Coal Hollow Mine 025005 Technical staff site inspection, 9/30/2014

Inspection Report

Permit Number:	C0250005
Inspection Type:	TECHNICAL
Inspection Date:	Monday, September 29, 2014
Start Date/Time:	9/29/2014 2:00:00 PM
End Date/Time:	9/30/2014 12:30:00 PM
Last Inspection:	Tuesday, September 09, 2014

Site: **COAL HOLLOW**

Above: Pit 10. Below: Kirk Nichols addresses Cheryl Parker, Lisa Reinhart, Joe Helfrich, Steve Christensen, Amanda Daniels, and Keenan Storer

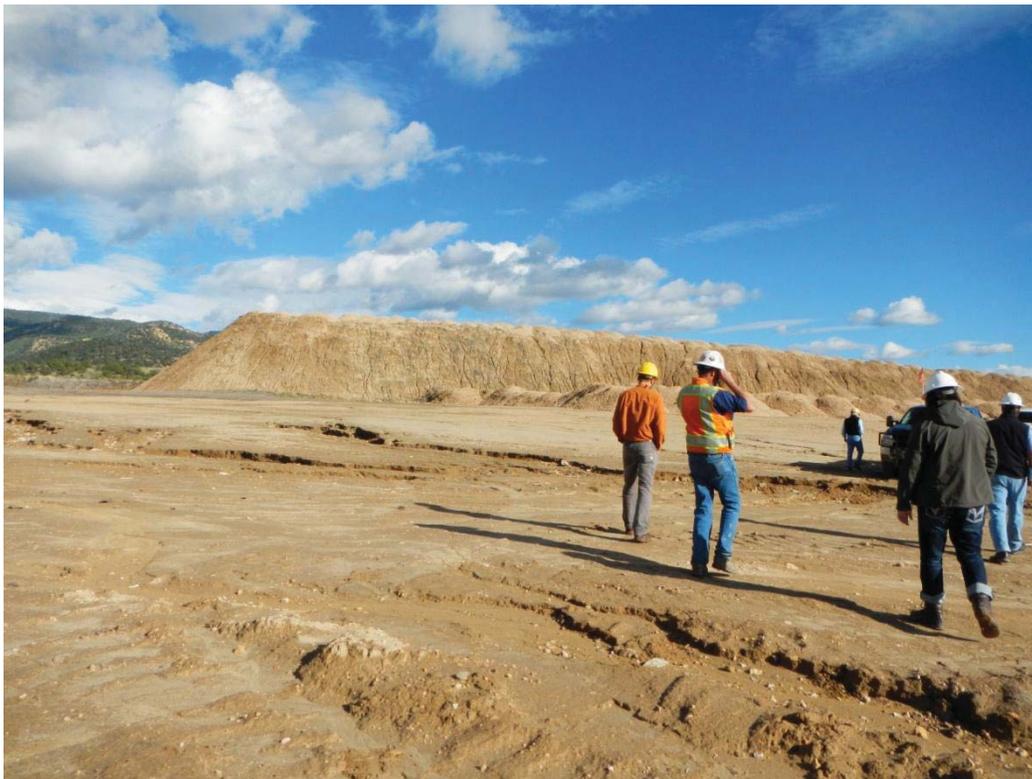
The coal seam was exposed in Pit 10 which has been opened on about one quarter of its length. Pit 10 may be the location of the proposed underground portals. The highwall in pit 10 is benched every 40 feet (two benches) and the alluvium height is approximately 30 ft. for a total of 110 ft. of cover. The 40 ft highwall above the portals would be shot-creted to prevent sloughing of the shale.

The underground mining proposal is under review as Task 4652. The coal seam was exposed in Pit 10 which has been opened on about one quarter of its length. The access to Pit 10 is through Pit 9. Pit 10 may be the location of the proposed underground portals, although the application describes the location as Pit 11. The highwall in pit 10 is benched every 40 feet (two benches) and the alluvium height is approximately 30 ft., for a total of 110 ft cover at this location. The proposed configuration of the underground access is shown on Dwg 5-3B of Task 4652, under review. The 40 ft highwall above the portals would be shot-creted to prevent sloughing of the shale. Pit 10 is flooded with water coming from the alluvium. The alluvial water management plan described in the MRP had not been instituted for this pit.
